ITEM NUMBER	14.3
SUBJECT	Post Exhibition - Site-specific DCP and Planning Agreement for land at 142-154 Macquarie Street Parramatta (Cumberland site)
REFERENCE	RZ/15/2014 - D06738705
REPORT OF	Project Officer
LANDOWNER	Landmark East Pty Ltd
APPLICANT	Dyldam

To report to Council the outcome of the public exhibition of the Planning Proposal and supporting site-specific Development Control Plan and Planning Agreement for 142-154 Macquarie Street, Parramatta, and to seek re-exhibition of the draft Development Control Plan and Planning Agreement.

Figure 4.3.3.7.26 – Control diagram: Setbacks to towers above podium

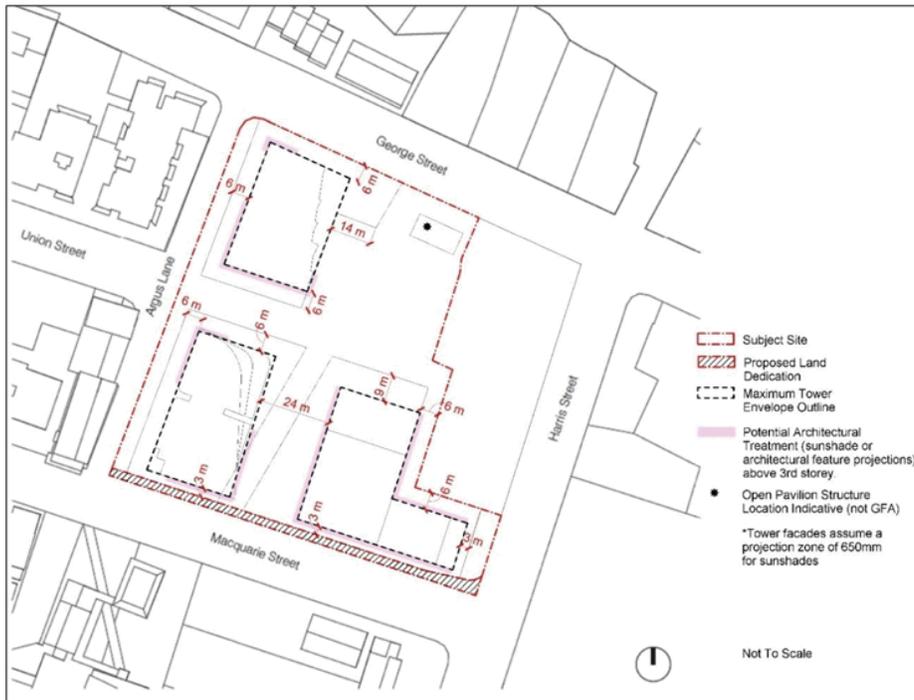
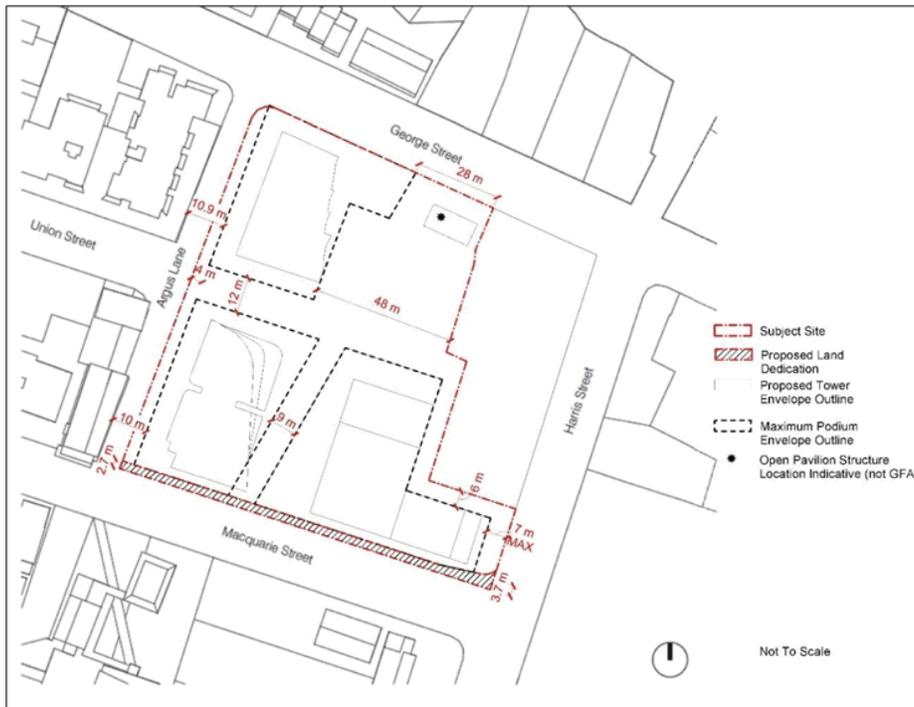
Transport for New South Wales (TfNSW)	
<p>A revised joint submission from TfNSW and RMS requested that:</p> <ul style="list-style-type: none"> The road widening reservations as depicted within Attachment 3 are to be dedicated as public road (at no cost to Council, RMS and TfNSW) and formalised into a draft Planning Agreement. 	<p>Council, TfNSW and the applicant have worked together to ensure that the Planning Agreement addresses the land reservation requirements on Macquarie and Harris Streets needed for Parramatta Light Rail and other Transport agencies. A more detailed discussion of the Planning Agreement will be provided later in this report.</p> <p>Moreover, the draft Development Control Plan has also been amended to identify these setbacks and make changes to the building form resulting from the new setbacks (see at Attachment 2).</p>

31. In order to accommodate the land reservation required by Parramatta Light Rail as specified in **Attachment 3**, the Development Control Plan for the site has been amended so that the two southern towers have 'shifted north' from Macquarie Street. The separation distance between the northern and southern towers has been reduced. Council's Urban Design Officers consider that the resulting separation distance between the towers is still acceptable.
